Check list for changing EMI strap design of MiniSAS HD external connector

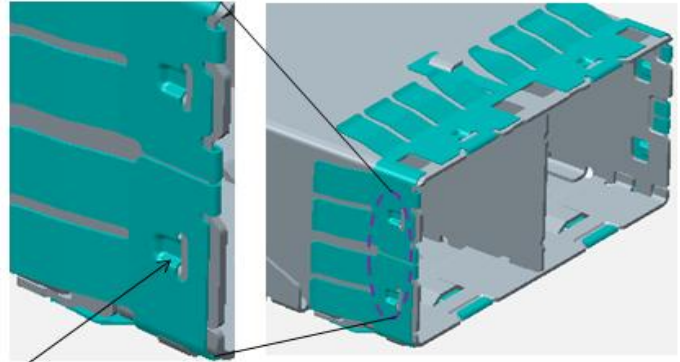
Current latches are shaped by lancing and withstand strength is weak

loosened EMI strap

These latches will be shaped by embossing

1> Current EMI strap is easy to be loosened due to external force, change the latch shape will reduce this possibility.
